DAYLIGHT AND SUNLIGHT

Illustrated drawing 214: Section 03 with 25° daylight lines

1: Illustration showing relationship on South Street

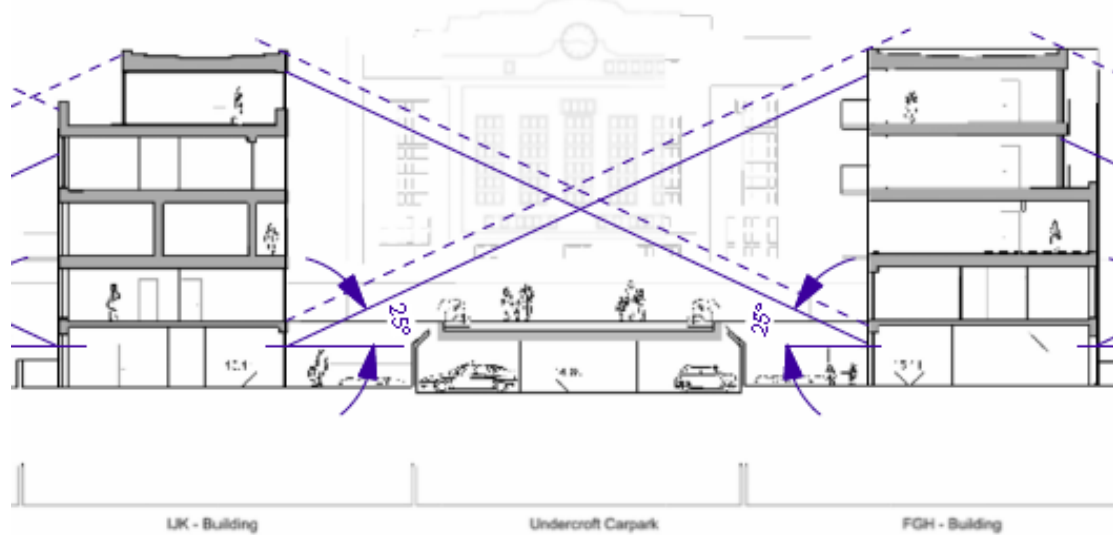
We have attached examples of measuring these 2m 25° lines on the drawings as submitted (see below). These illustrations show that the proposals very rarely comply with condition(a). As such it brings into question the actual daylight within the scheme.

Furthermore the areas that fall below these guidelines need to be assessed in terms of the 4m (measured sideways). This is not feasible in large areas of the scheme due to long monolith blocks that are proposed. This is shown clearly within the daylight report where several of readings show a vertical sky component (VSC) of less than 27%.

Please note dashed lines show the height at which rooms will start achieving 'good' daylight.

As you can see from illustration 1 above this 43° line at the boundary offers a large impact on it's neighbours in terms of diffused daylight and also future potential development. The same can be said for illustration 3. The report submitted with the application assess the daylight and sunlight within the actual existing properties but does not make any assessment of the actual impact the proposals have in terms of proximity to boundaries and overall impact at these locations. This is not acceptable as one of the boundaries is public open space that will have a huge reduction in daylight and this impact has not even been considered.
